NORTHERN STATES POWER COMPANY

MONTICELLO NUCLEAR GENERATING PLANT
Docket No. 50-263 License No. DPR-22

Supplement No. 1 to
License Amendment Request Dated September 19, 1977

Control Rod Housing Pressure Boundary Weld - IWB-1220(b)(1) Analysis Summary

Figure 1 CRD Housing Welds

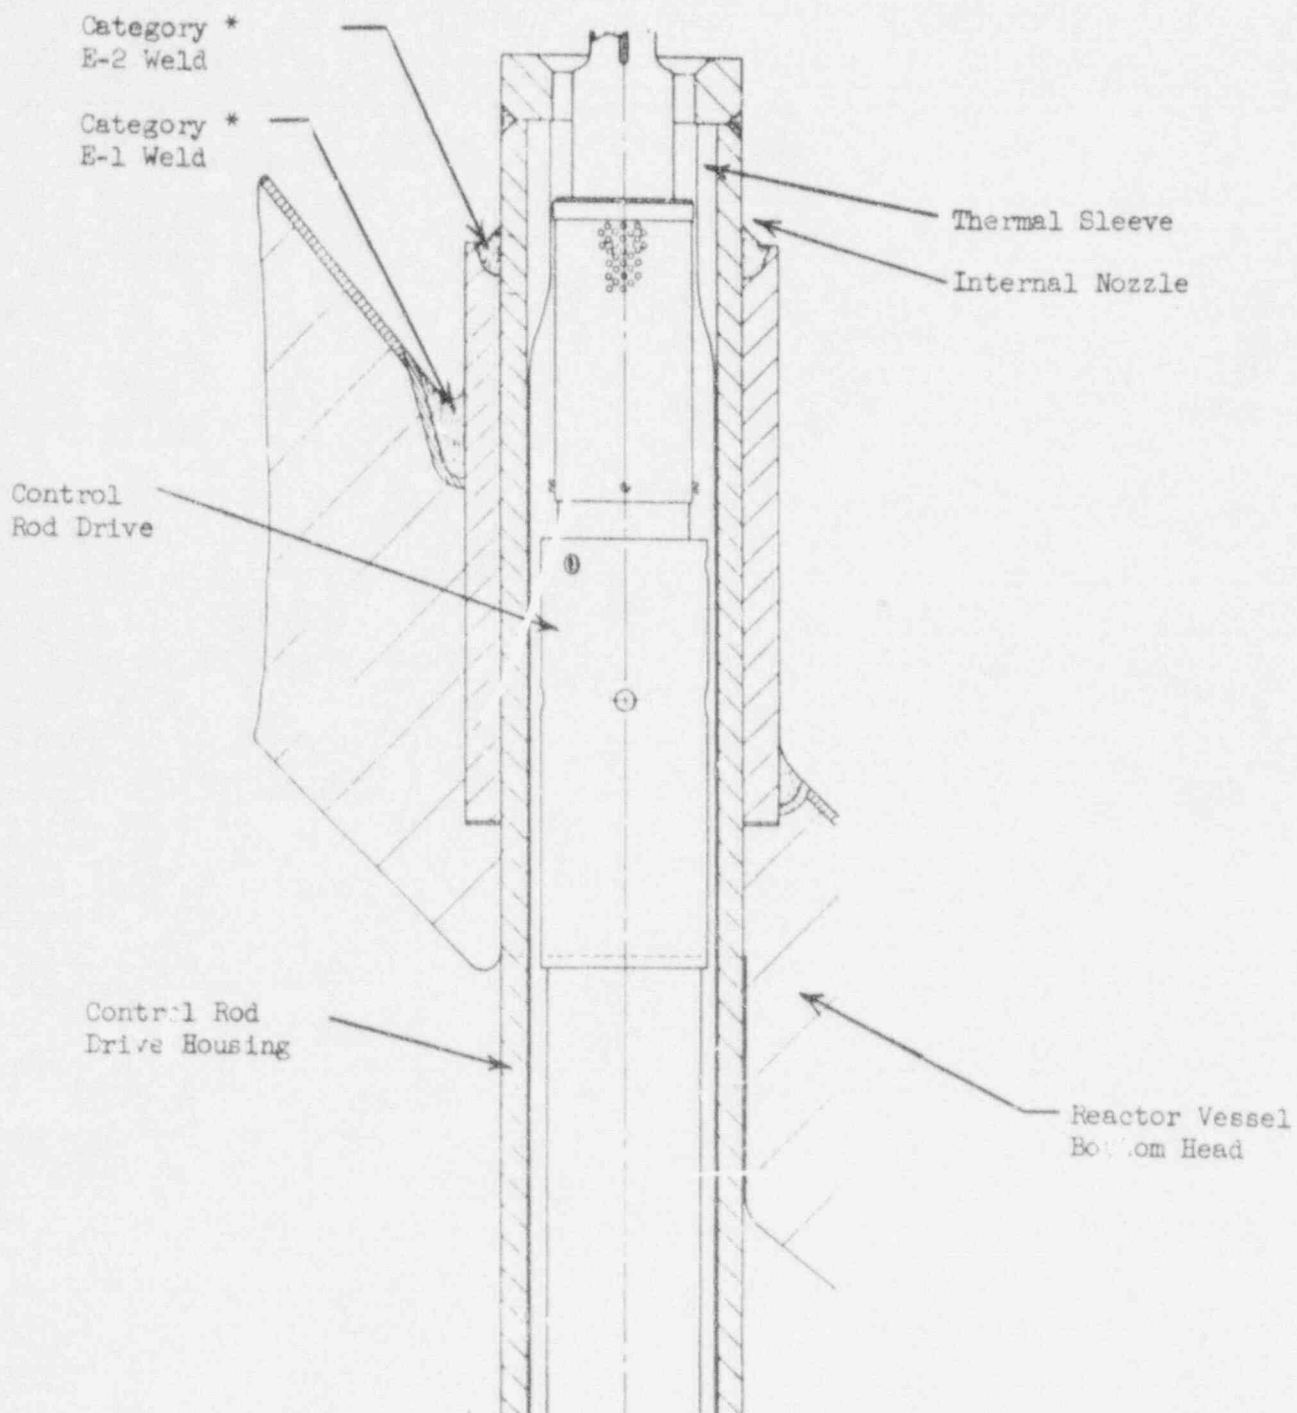
Refer to Figure (1). Failure of control rod housing to internal nozzle weld results in maximum break area of:

$$D_1 = \text{Maximum internal nozzle diameter} = 6.000 \text{ inch}$$

$$D_2 = \text{Minimum CRD housing outside diameter} = 5.985 \text{ inch}$$

$$A_m = \frac{\pi(D_1 + D_2)(D_1 - D_2)}{4} = 0.14 \text{ in}^2$$

The CRD support structure (Reference 1) prevents the housing from dropping far enough to clear the vessel penetration.

The maximum two-phase vessel blowdown through this break area (Reference 2, Figure 2-4) assuming saturated liquid at 1025 psia is 7.8 lb_m/sec.

The capacity of the RCIC system is 400 gallons/minute of water (Reference 3). Assuming a water temperature of 140°F, this corresponds to a makeup rate of 54 lb_m/sec. The coolant loss through a failure of the control rod housing weld is therefore well within the capacity of the system.
